STELEANTIS PARTS & SERVICES		Technical Service Bulletin (TSB) Low Oil Pressure			
REFERENCE:	TSB: 09-006-23 REV. C GROUP 09 - Engine	Date:	July 22, 2023	REVISION:	09-006-23 REV. B
VEHICLES AFFECTED:					PPLICABILITY: MEA IAP CH
CUSTOMER SYMPTOM:	Customers may experience a Malfunction the technician may find that the following P06DD - Engine Oil Pressure Concustomers may also comment on the form	ng Diagnos trol Circuit	stic Trouble Code (DT

This bulletin supersedes Technical Service Bulletin (TSB) 09-006-23 REV. B, date of issue May 10, 2023, which should be removed from your files. All revisions are highlighted with **asterisks** and include updated RSU number, model year, build dates and LOP.

This bulletin involves inspecting and if necessary replacing the timing chain cover (oil pump).

Fig. 1
Graph Showing Correct And Not Correct Values

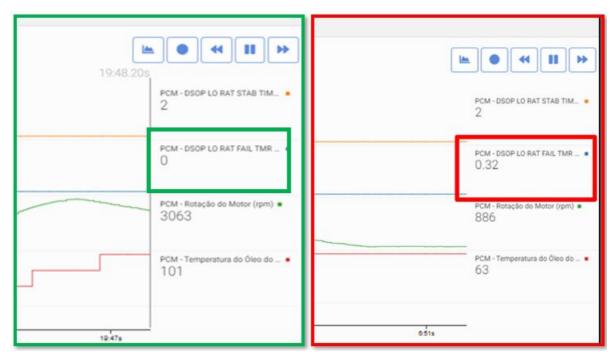
- 1. Using wiTECH check if DTC P06DD is set in the Powertrain Control Module (PCM).
- 2. Was DTC P06DD found in the PCM?
 - YES>>> Replace the timing chain cover. Proceed to Step 6.
 - NO>>> Proceed to Step 3.
- 3. Start the engine at let it run at idle until the engine oil temperature reaches more than 85° C (185° F).
- 4. Create a graph of "DSOP LO RAT FAIL TMR" and review the value. If it shows anything but "0", the timing cover needs to be replaced (Fig. 1).

NOTE: The "DSOP LO RAT FAIL TMR" value can change in less than 20 seconds, then the oil pump (timing chain) is faulty and will need to be replaced.

- 5. Did the "DSOP LO RAT FAIL TMR" value read anything but "0"?
 - YES>>> Create a screen shot of the graph showing values other than "0" and attach it to the work order. Proceed to Step 6.
 - NO>>> If the value always shows "0" and DTC P06DD was not found, this bulletin has been completed. Use Inspection LOP (09-65-01-74) to close the active RSU.
- 6. Replace the timing chain cover. Refer to the detailed service procedures available in DealerCONNECT/ Service Library under: 09 - Engine, 1.3L I4 16V Multi Air Turbo / Valve Timing / Cover(s), Engine Timing / Removal and Installation.
- 7. Using wiTECH clear any DTCs that may have been set.
